APPLICATION NO.	FILING DATE	FIRST NAMED INVENTOR	ATTORNEY DOCKET NO.	CONFIRMATION NO.
10/603,568	06/25/2003	Daniel S. Choi	WEB-922-CIP-US	3360

Office Action Summary

DETAILED ACTION

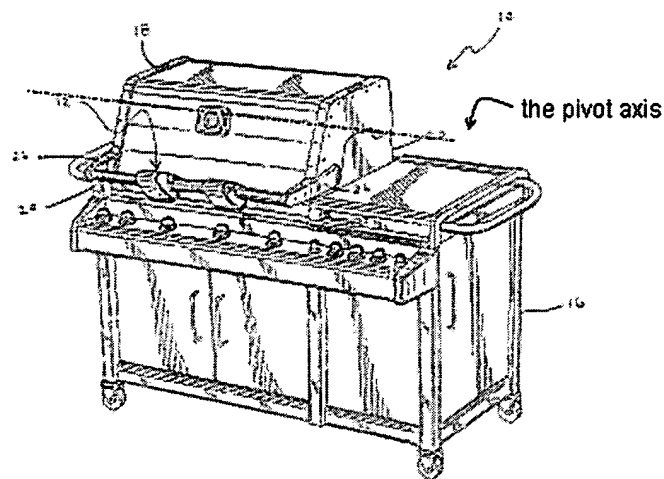
2. The drawings are objected to under 37 CFR 1.83(a). The drawings must show every feature of the invention specified in the claims. Therefore, the handle being attached to the upper member and being generally parallel to the horizontal axis must be shown or the feature(s) canceled from the claim(s). No new matter should be entered.

Note: Figure 3 and page 10; lines 10-15 describes the arrow being "... open position ... closed position ... etc."). For example, "*the pivot axis*" would be a line of axis that passes the hinge from one end of the upper/lower member to the other end.

Corrected drawing sheets in compliance with 37 CFR 1.121(d) are required in reply to the Office action to avoid abandonment of the application. Any amended replacement drawing sheet should include all of the figures appearing on the immediate prior version of the sheet, even if only one figure is being amended. The figure or figure number of an amended drawing should not be labeled as "amended." If a drawing figure is to be canceled, the appropriate figure must be removed from the replacement sheet, and where necessary, the remaining figures must be renumbered and appropriate changes made to the brief description of the several views of the drawings for consistency. Additional replacement sheets may be necessary to show the renumbering of the remaining figures. Each drawing sheet submitted after the filing date of an
